Appendix 5.9

Natural England Correspondence

From: [REDACTED]
Sent: 06 August 2020 18:24
To: [REDACTED]
Cc: [REDACTED]
Subject: RE: UDS 6742/312493 - North Killingholme Power Project - Natural England DAS

Development proposal and location: Time extension for implementation of granted Development Consent Order (DCO) for the North Killingholme Power Project.

APPENDIX A – SITE LAYOUT

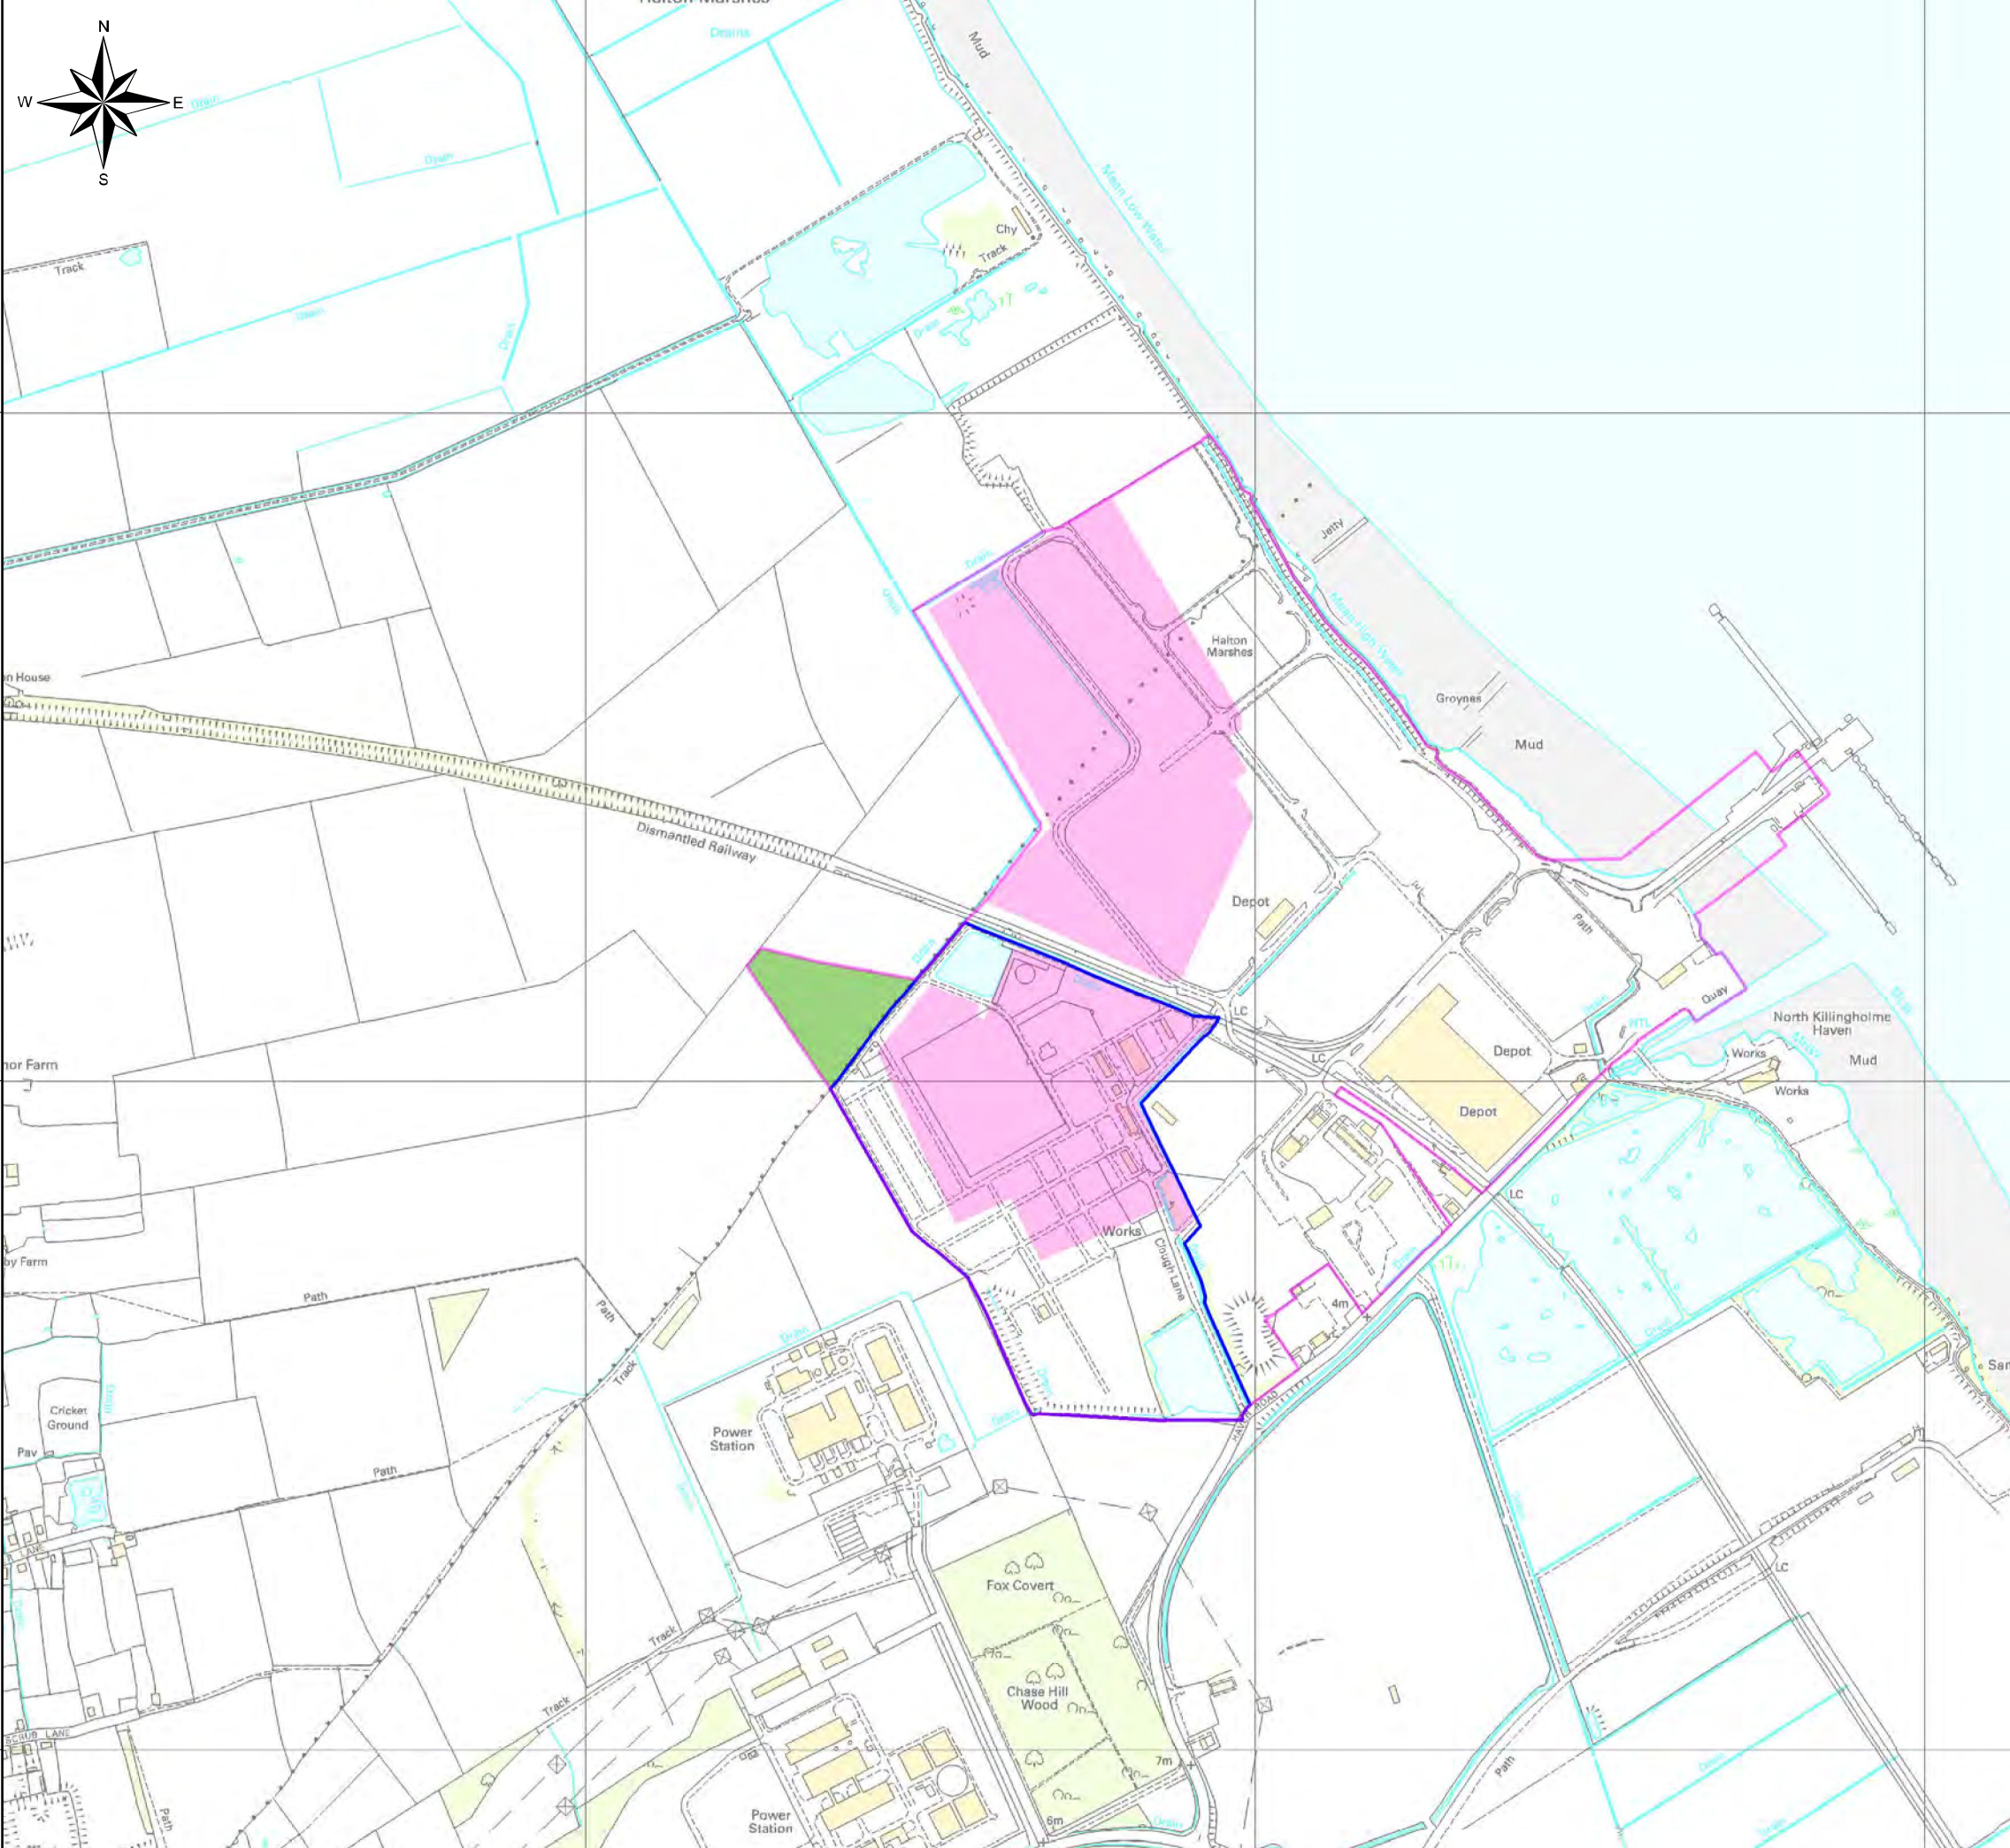
Thank you for the below response and further clarifications. It would be useful to get a drawing of the locations that the hoarding will be erected, as it is a little confusing to work out, but if this is not possible it is not essential.

'Thank you for providing this additional explanation. I have referred back to the DCO, where it appears that the mitigation measures include 5m high acoustic hoarding/visual screening along the northern and western boundaries of the operations area. This is slightly different to "along the northern boundary of the Operations and Construction Laydown Area" as you have described, so we would welcome further clarification on which is correct.

Thank you for providing this additional explanation. I have referred back to the DCO, where it appears that the mitigation measures include 5m high acoustic hoarding/visual screening along the northern and western boundaries of the operations area. This is slightly different to "along the northern boundary of the Operations and Construction Laydown Area" as you have described, so we would welcome further clarification on which is correct.

In relation to the point about hoarding, you are correct – Requirement 49 relates to hoarding along the western and northern boundaries of the Operations Area only – apologies for the error here.

However, the ES states that *'The northern, eastern and north-western boundaries of the Operations Area and associated Construction Laydown Area should be fitted with physical barriers or hoardings.'*

The outline CEMP (Section 3.2) also includes provision for the *'Design and use of site hoarding and screens, where necessary, to provide acoustic screening at the earliest opportunity'* and requires that *'To reduce the distribution of noise all construction areas should be enclosed within plywood faced, timber framed boundary hoarding which has a minimum height of 2.4 m and a surface density not less than 7kg/m²'*.

Acoustic hoarding around the northern and north-western boundaries of the Construction Laydown Area would therefore be delivered via the requirements of the CEMP.

Principal Project Area, which is outside both the Construction Laydown Areas and Operations Area (see appended Site Layout Figure in Appendix A), adjacent to intertidal habitats on the foreshore.

APPENDIX B – OPERATIONAL NOISE MODELLING

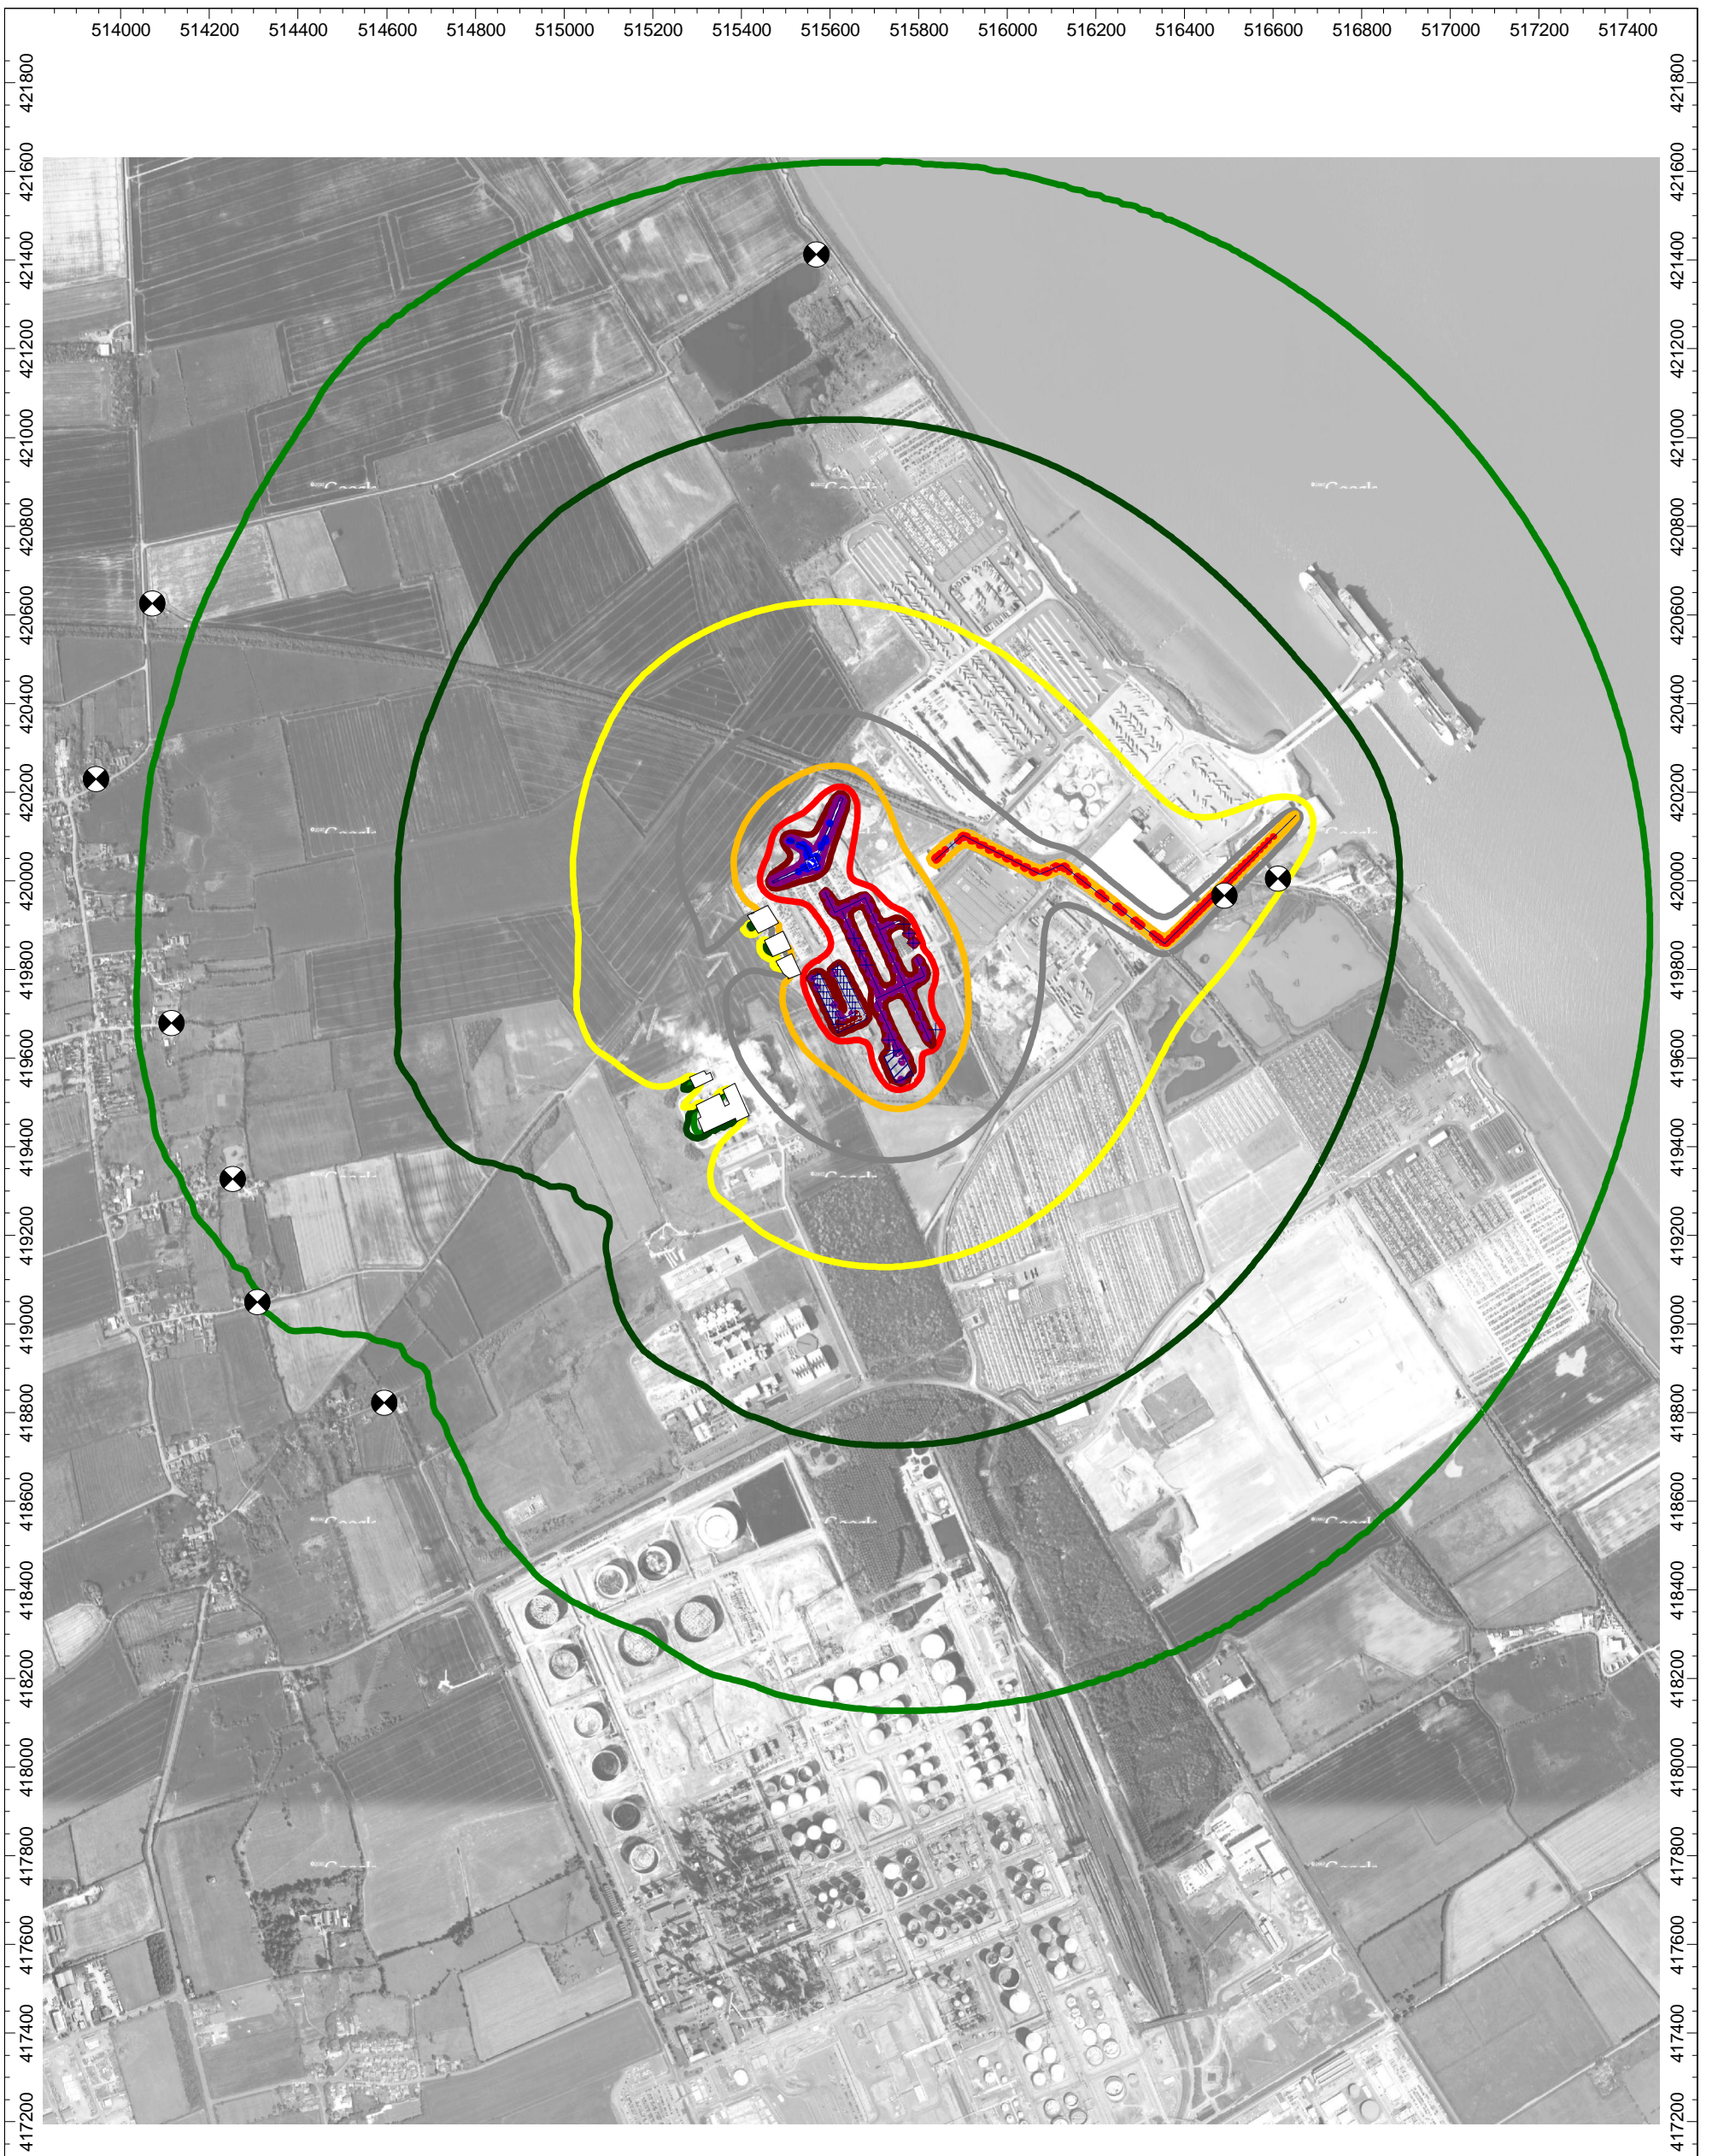
Regarding breeding birds associated with the Humber estuary designations, we note that the survey results recorded a pair of marsh harriers, “possibly exhibiting courtship display ... in late March over Halton Marshes”. Natural England is aware that there were nesting marsh harriers near to Halton marshes in

2019. This species is known to change nest sites each year, and therefore we recommend that further evidence is provided to identify the zone of potential noise disturbance impacts as a result of the construction and operation of the proposed development. However, we appreciate that the justification provided within the noise impact assessment in the original application may be sufficient, but we are unable to view this evidence.

Operational noise modelling was completed for the original ES⁵. The most noise-intensive scenario for operational noise assessed was Scenario E, which predicted a maximum impact at Halton Marshes of <45 dB(A)⁶, with the noise contours from this modelling included in Appendix B to this note. The majority of Halton Marshes would experience a worst-case impact of <40 dB. The nearest Noise Sensitive Receptor (NSR1, at the northern edge of Halton Marshes, see Appendix C) recorded minimum background noise levels of 38.5 dB during noise surveys to inform the original DCO application⁴. As worst-case predicted operational noise is not significantly different from background, no disturbance of marsh harriers is predicted to arise.
